Transalloys coal-fired power station, near eMalahleni, Mpumalanga Province

Motivation for amendment of the Integrated Environmental Authorisation

DEA Ref.: 14/12/16/3/3/3/97 (as amended)

February 2021

Figure 3: The proposed amendment development site alternatives 1 and 2 for the power plant and ash dump with Environmental Sensitivities (2021)

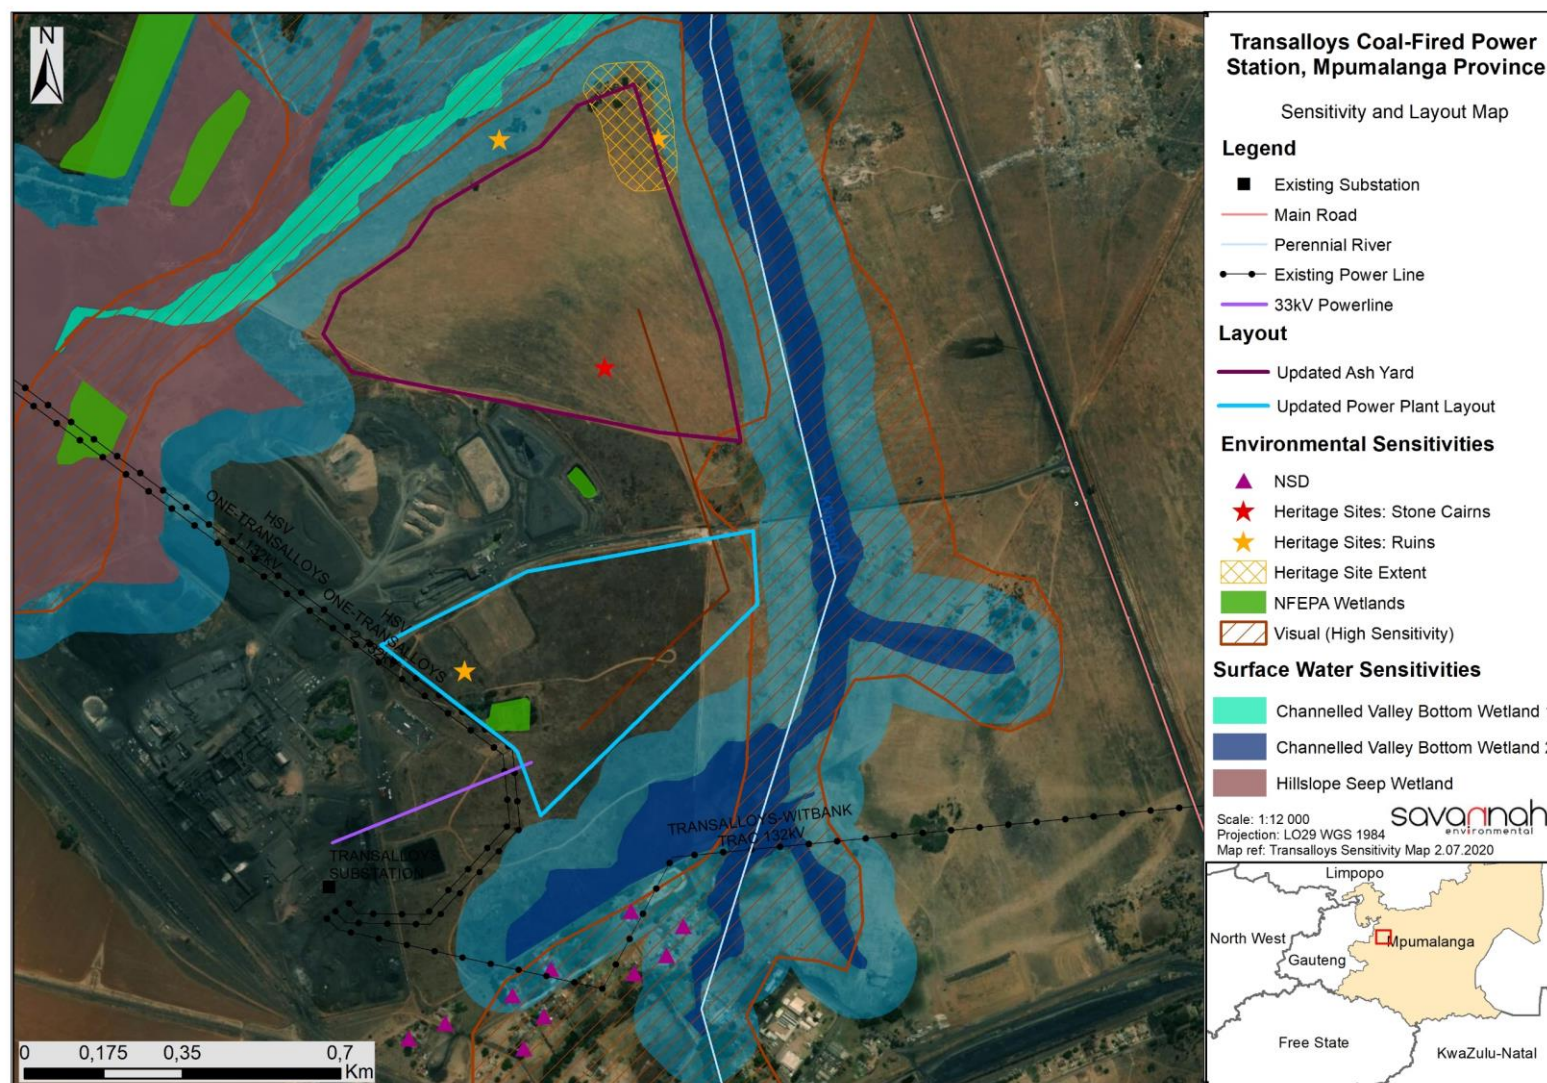
"3.1 Authorisation is granted for the establishment of Transalloys coal-fired power plant and associated infrastructure within site co-ordinates as indicated above. Developmental site alternative 1 is hereby approved for the ash dump location and developmental site 2 is hereby approved for the 135MW power plant and associated infrastructure."

Figure 4: Updated power plant and ash dump development site alternatives on site 2 and 1 respectively (A3 Map included in Appendix H). Illustrating the power plant and ash dump located outside of the wetland buffer

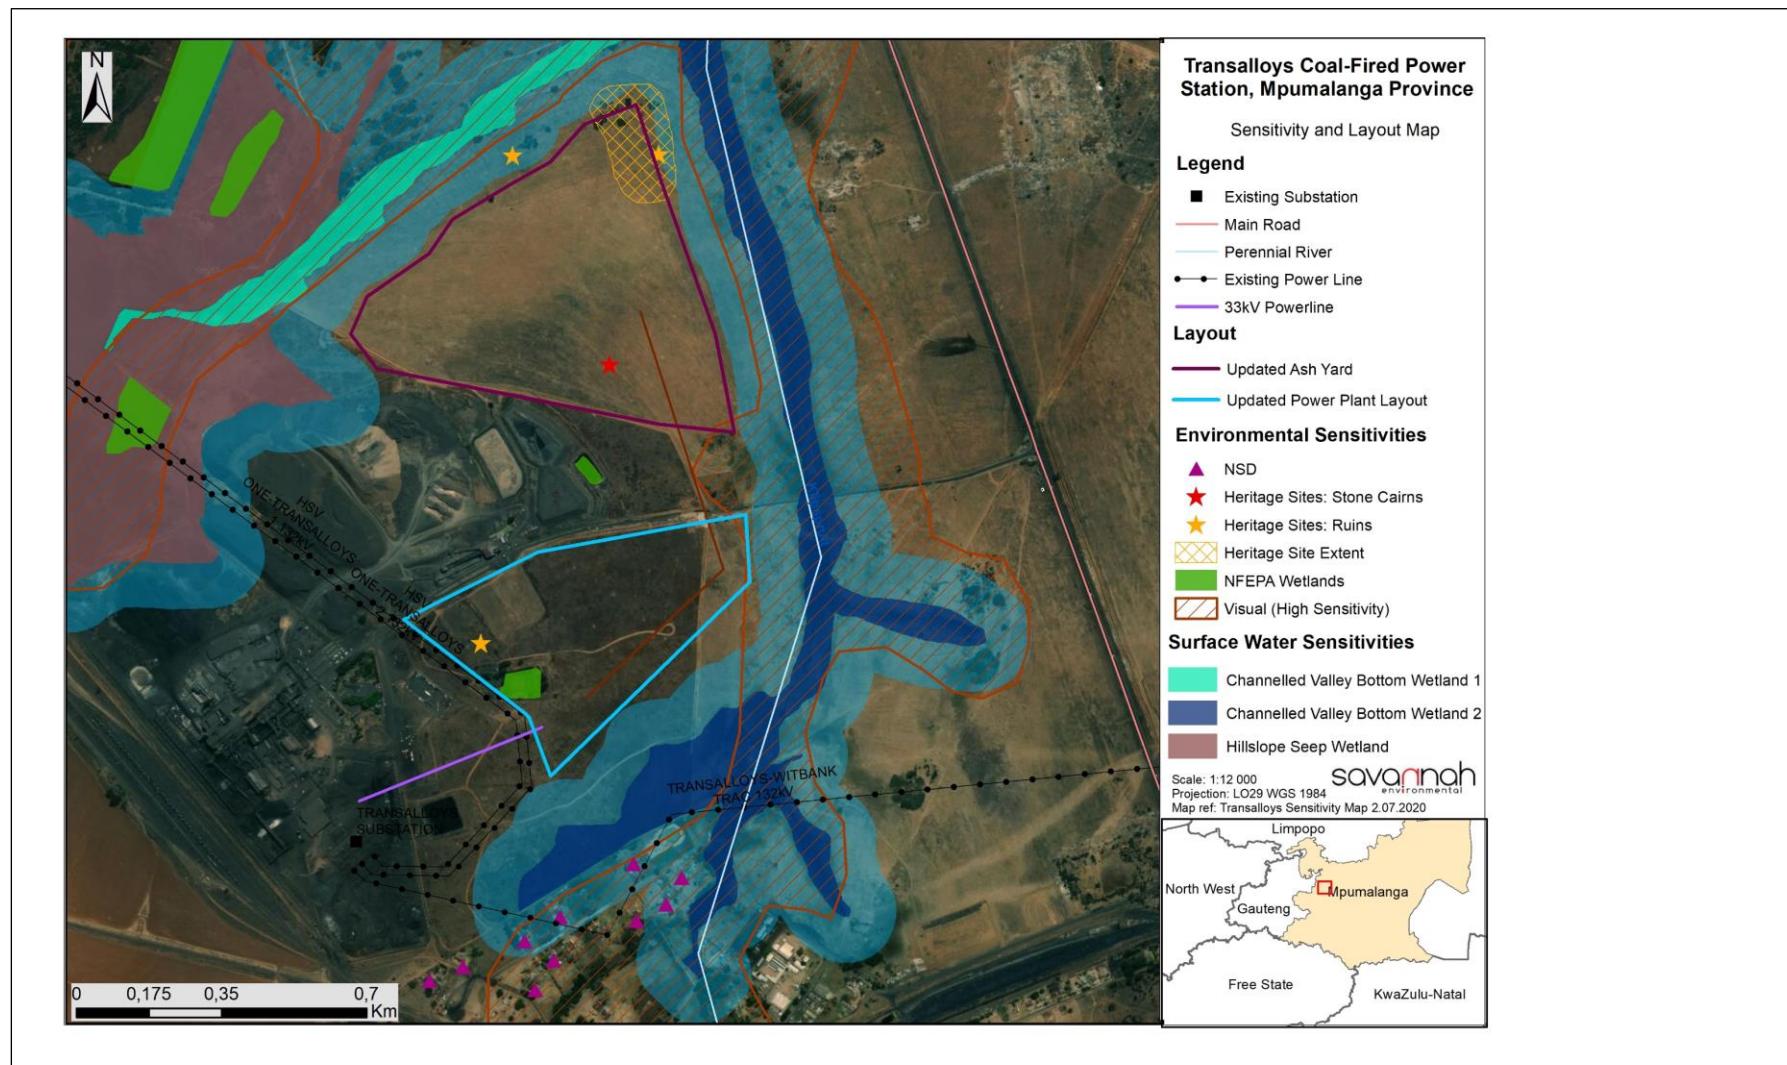
In order to maximise the power output of the plant, layout adjustments are required. A Transnet pipeline passing through the site initially allocated for the Ash disposal facility as was identified during detailed land audits, rendering the size of the site insufficient for the ash disposal facility, but large enough for the power plant facility. This necessitated exchanging the power station zone and the ash dump disposal zone (literally exchanging the location of the one for the other) as approved with Alternative 1 (150 MW) in the original integrated EA, issued 2 March 2016 (as amended). The need for amending the preferred site development alternative

(150 MW site development) as per the FEIR submitted on the 26 May 2015, taken into consideration with the swapping of the locations of the ash disposal facilities (Site 1) and power plant (Site 2)) also allowed for minor optimisations of the facility, which was applied to the updated map provided for approval in this motivation report (Figure 3 and 4). During initial investigations for the FEIR submitted in May 2015 development site 1 approved for the 55 MW power plant as well as development site alternative 1 & 2 considered for the 150 MW plant avoided the wetland buffers present at the site. Subsequently, the wetland buffers for development site alternative 1 for the approved 55 MW power plant reduced the size of the ash disposal facility considerably making it insufficient to support the power plant, hence now the consideration of both development site alternative 1 and 2 to allow functionality of the 135 MW power plant and associated ash dump.
